## Comments on memory and allan variance

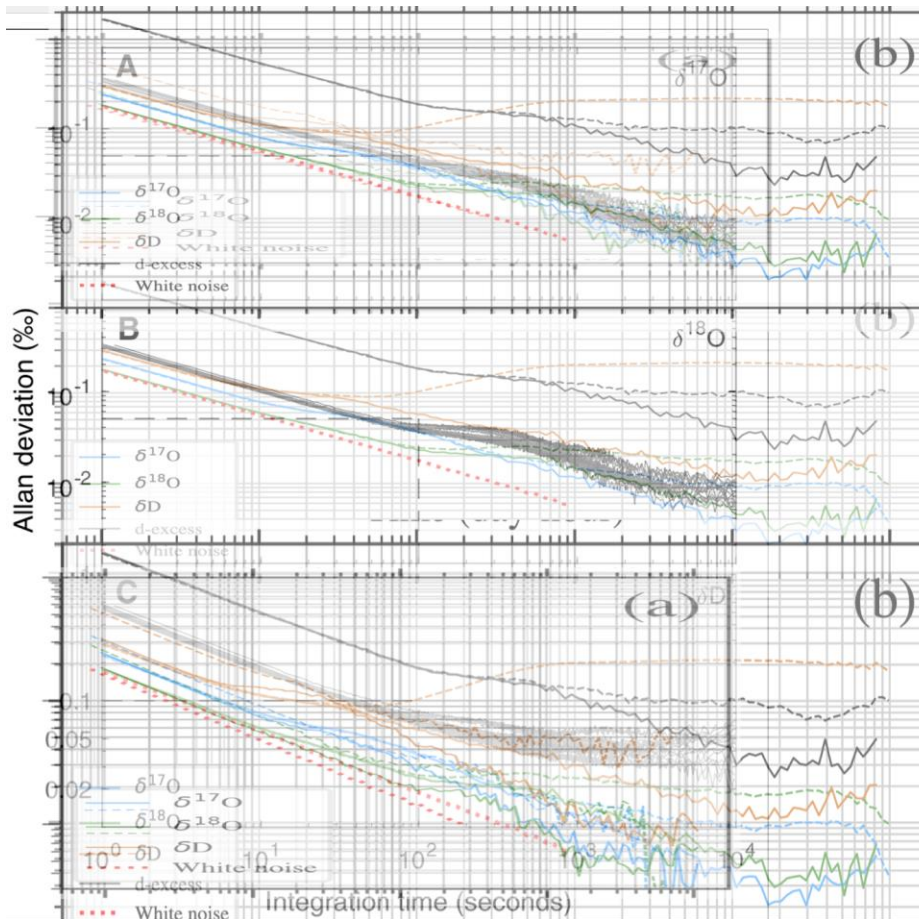
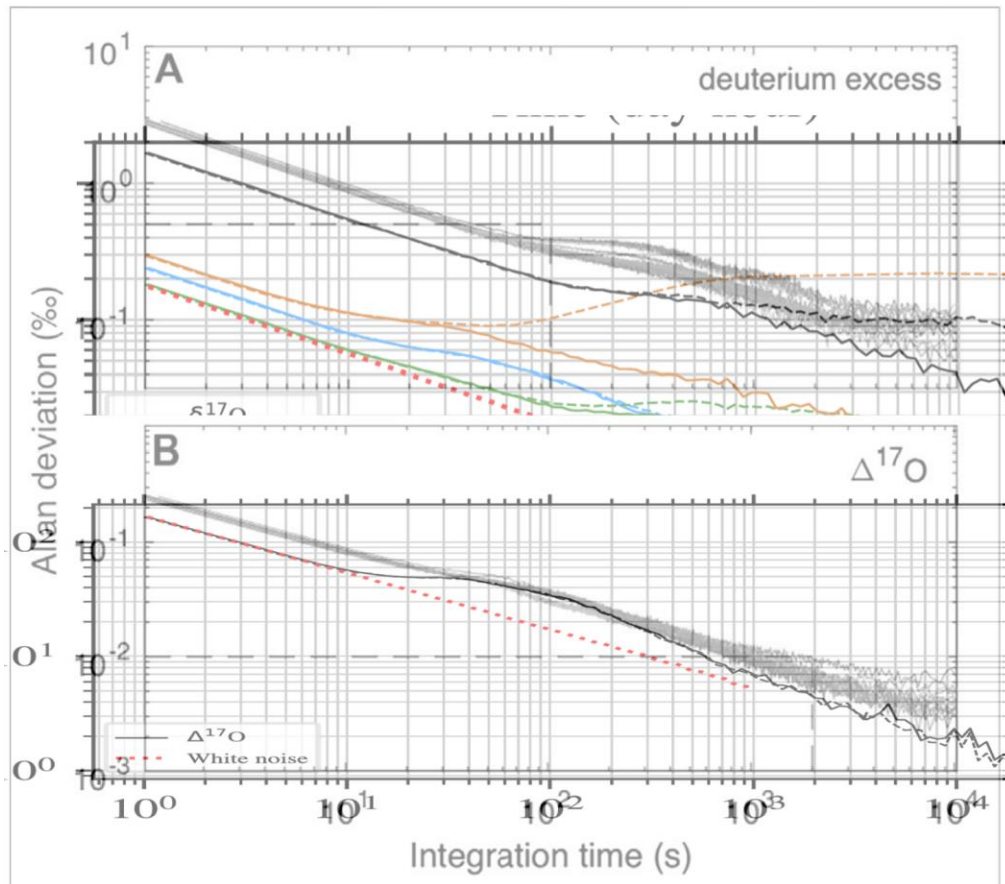
Especially considering that this paper demonstrates that the high-frequency variability is owed to the stability of each instrument and not the vaporization module itself, these plots all fall well within the range of values published by Steig 2021, whose data are overlain on Figs 3 and 8 below and deviate notably only at high-frequencies. The Steig 2021 data are from much shorter runs of calibration standards during the South Pole ice core measurements, and they achieve similar results for all isotopes, especially when compared with the older instrument in figure 8 or the untruncated data in figure 3. The Steig 2021  $\delta D$  values are similar to the performance shown in figure 8 and far exceed the un-trimmed data, even without the extensive 16-hour trimming. This actually suggests that the memory internal to this new vaporization system is more significant than the memory of the system used in that paper. Can you speculate about why this very long data trimming is necessary or comment on your data processing workflow for routine measurements given this limitation? Please ensure that your language around stability and memory is better placed within the context of this type of similar vaporization system.
